*Note to Editor: Unchanged text shown in gray font (para/Figure numbering may have changed). Figures are thumbnails only. Notes such as this (titled “Note to Editor” are info only and not to be included in the draft).*

## 142. Physical Coding Sublayer and Physical Media Attachment for Nx25G-EPON

Figure 142-3 ONU burst structure, 3 zones

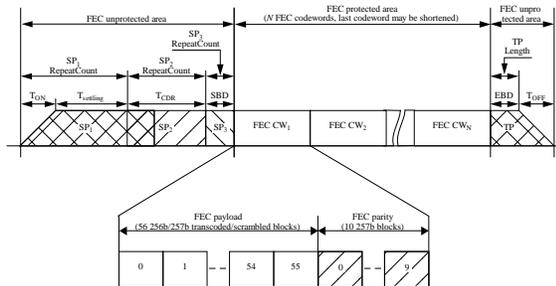
The upstream burst begins with a FEC-unprotected area (~~Sync Pattern~~SP), comprising several explicit zones, each playing a separate role: SP<sub>1</sub> zone, optimized for laser on (T<sub>on</sub>) and Automatic Gain Control (AGC, T<sub>settling</sub>); SP<sub>2</sub> zone, optimized for Clock and Data Recovery (CDR, T<sub>CDR</sub>); and SP<sub>3</sub> zone, optimized for the Start of Burst Delimiter (SBD)

pattern. Each SP element is a multiple of 257 bits, aligning with the Clause 142 PCS line code of 256B/257B. This three zone arrangement is shown in Figure 142-3 for both normal operation (granted transmission) and the discovery operation. In the case of the discovery operation, the FEC-protected area comprises a single (shortened) FEC codeword.

Figure 142-4 Burst structure, 2 zones

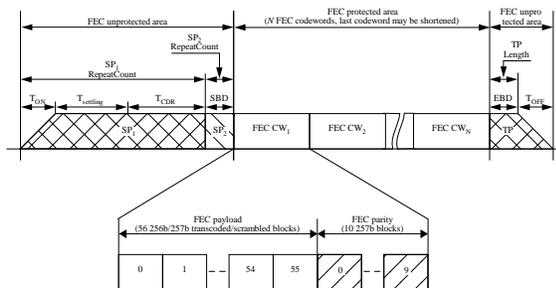
In some implementations, only two explicit zones are needed: SP<sub>1</sub> zone, optimized for laser on (T<sub>on</sub>), Automatic Gain Control (AGC, T<sub>settling</sub>), and Clock Data Recovery (CDR, T<sub>CDR</sub>); and SP<sub>2</sub> zone, optimized for the Start of Burst Delimiter (SBD) pattern. This arrangement is shown in Figure 142-4 for the normal (granting operation) and discovery operation. In the case of the discovery operation, the FEC-protected area comprises a single (shortened) FEC codeword.

Figure 142-6 PCS Input process state diagram

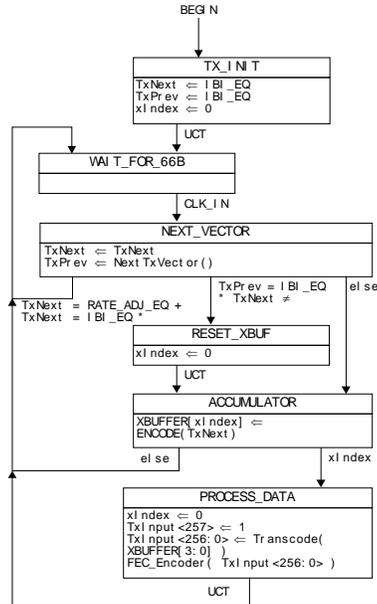
The PCS Input [functional block process](#) accepts two consecutive 36-bit transfers from the xMII interface and converts them into a single 72-bit tx\_raw vector. The Input [block process](#) discards all RATE\_ADJ\_EQs to allow for insertion of FEC parity blocks by the PCS Transmit process (see [TBD-142.2.5.4.3+42.x.x](#)). IBI\_EQs not required to complete a 256B/257B block at the end of a transmission are also discarded at the Input [block process](#). All other 72-bit vectors are encoded into 64B/66B blocks. Four 64B/66B blocks are accumulated, [scrambled](#), and transcoded into a single [scrambled](#)-256B/257B block and copied to the FEC Encoder. A single bit indicating the accompanying 256B/257B vector has been scrambled is appended to the vector which is then stored in the INPUT\_FIFO.

Figure 142-7 PCS Framer process state diagram

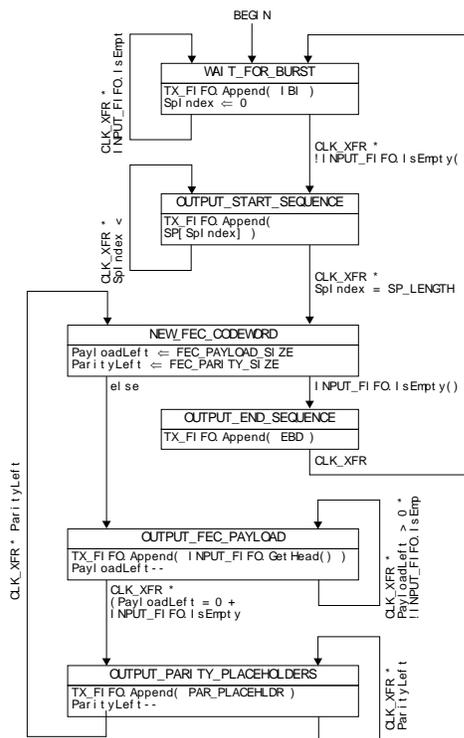
The PCS Framer process monitors data from the INPUT\_FIFO and transfers it to the TX\_FIFO, inserting inter-burst idle (IBI), ~~start of burst delimiter (SBD)~~ *SP*, parity placeholders (PAR\_PLACEHLDR), and ~~end of burst delimiter (EBD)~~ as appropriate. While the INPUT\_FIFO is empty, the PCS Framer process appends IBI to the TX\_FIFO. When the INPUT\_FIFO first becomes not empty, indicating the beginning of a burst, the ~~Syne Pattern (SP)~~ *SP* is appended to the TX\_FIFO. Once the complete ~~SBD-SP~~ *SP* is appended to the TX\_FIFO, the ~~inputFramer~~ process begins transferring data from the INPUT\_FIFO to the TX\_FIFO. When sufficient data for a full FEC payload has been transferred to the TX\_FIFO, or the end of the burst is detected, as indicated by an empty INPUT\_FIFO, the PCS Framer process appends sufficient PAR\_PLACEHLDR blocks to the TX\_FIFO to allow insertion of the FEC parity codeword into the data stream by the PCS Transmit process. Additional FEC codewords are allowed for until the end of the transmission is indicated by an empty INPUT\_FIFO, at which point the ~~PCS-Framer process~~ *process* appends the EBD to the TX\_FIFO followed by IBI.

Figure 142-8 PCS Transmit process state diagram

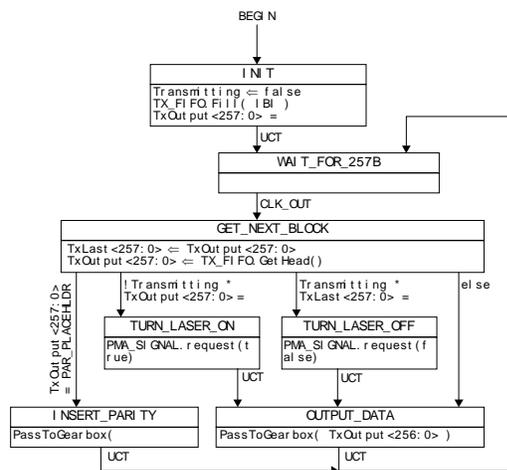
The PCS Transmit process transfers data from the TX\_FIFO or FEC Encoder to the ~~GearboxPMA~~.

On each transition of the CLK\_OUT to True the Transmit process retrieves one 258-bit block of data from the TX\_FIFO. If the retrieved 258-bit block is equal to SP[0] and Transmitting is False, indicating the beginning of a transmission, the argument of the PMA\_SIGNAL.request is set to True indicating that the laser needs to be turned on, and the lower 257-bits of the 258-bit block are sent to the GearboxPMA. If the retrieved 258-bit block is EBD and Transmitting is True, indicating the end of a transmission, the argument of the PMA\_SIGNAL.request is set to False indicating that the laser needs to be turned off, and the lower 257-bits of the 258-bit block are sent to the GearboxPMA. If the retrieved 258-bit block is PAR\_PLACEHLDR, indicating a FEC parity codeword needs to be inserted in the data stream, 257-bits of the parity are retrieved from the PARITY\_STAGING\_BUFFERFEC encoder and sent to the GearboxPMA. In all other cases, i.e., normal transmission data, the lower 257-bits of the 258-bit block retrieved from the TX\_FIFO are sent to the GearboxPMA.

Figure 142-12 ONU Synchronizer state diagram

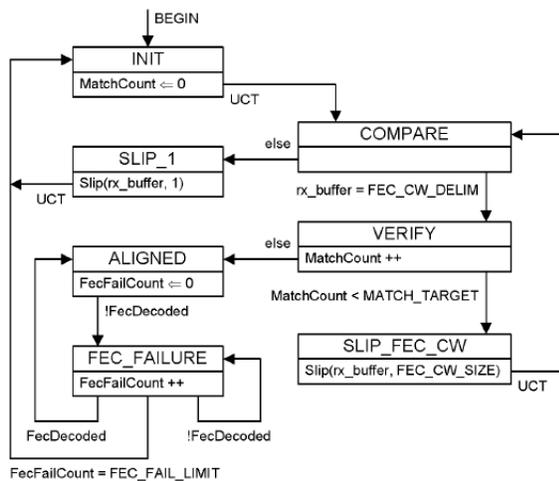
Editor's Note: the text below was adopted from 76.3.3.2 and will need to be aligned with the new synchronizer SD.

The ONU synchronization receives data via the {TBD}-bit PMA\_UNITDATA.indication primitive. The synchronizer forms a bit stream from the primitives by concatenating requests with the bits of each primitive in order from rx\_data-group<xx> to rx\_data-group<xx> (see Figure 142-10+0). It obtains lock to the FEC codewords within the bit stream using the mechanism shown in Figure 142- 3 and outputs {TBD} codewords to the FEC decoder function.

Figure 142-13 PCS Output state diagram

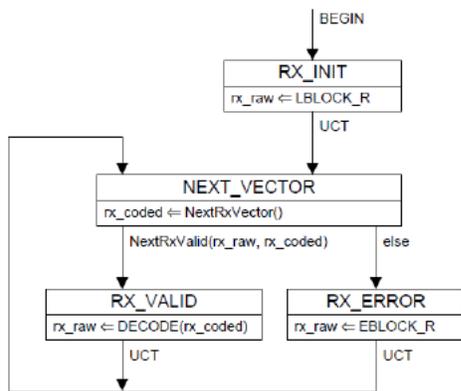
*Note to Editor; above fig was 142-17 Transmit/Encode SD*
